# Access Compliance Report

## Public Rights-of-Way

Intersection ID: 50008	Main Street: BERKELEY_PLACE_DR	Cross Street: SALERNO_DR	Location:	W
ADA ID: E5AF7917F8EB	Ramp Type: PerpDiag	Initial Pass/Fail: Fail	Overall Compliance: No	Severity Score: 25

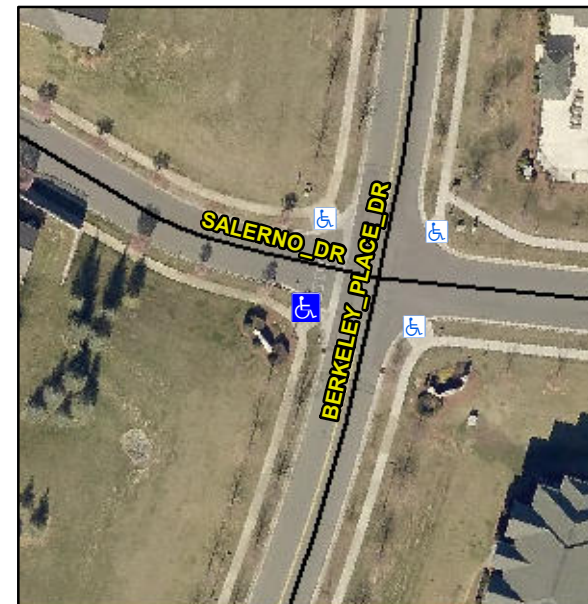
Compliance	Description	Data	Compliance	Description	Data
N/A	Ramp Length (in)	97.0	No	Ramp Slope (%)	18.0
Yes	Ramp Width (in)	52.0	Yes	Ramp XSlope (%)	1.0
N/A	Flare Type LT	N/A	N/A	Flare Type RT	N/A
N/A	Flare Slope LT (%)	N/A	N/A	Flare Slope RT (%)	N/A
N/A	Flare Traversable LT?	N/A	N/A	Flare Traversable RT?	N/A
N/A	Landing Length (in)	N/A	N/A	DWS Provided?	N/A
N/A	Landing Width (in)	N/A	N/A	DWS Contrast?	N/A
N/A	Landing Slope (%)	N/A	N/A	DWS Length (in)	N/A
N/A	Landing X Slope (%)	N/A	N/A	DWS Full Width?	N/A
N/A	Landing Curb? (Y/N)	N/A	N/A	DWS Offset (in)	N/A
N/A	Shared Landing?	N/A			
N/A	Gutter Ponding?	N/A	N/A	Gutter Slope (%)	N/A
N/A	Gutter Lip Ht (in)	N/A	N/A	Gutter X Slope (%)	N/A
N/A	Painted X Walk1?	No	N/A	Painted X Walk2?	Yes
	X Walk 1 Direction	To SE		X Walk 2 Direction	To NE
N/A	X Walk 1 Width (in)	N/A	N/A	X Walk 2 Width (in)	55.0
	X Walk 1 Slope (%)	0.8		X Walk 2 Slope (%)	1.7
	X Walk 1 X Slope (%)	0.7		X Walk 2 X Slope (%)	3.9

**Remove & Replace Curb Ramp With Two New Directional Ramps or Equivalent.**
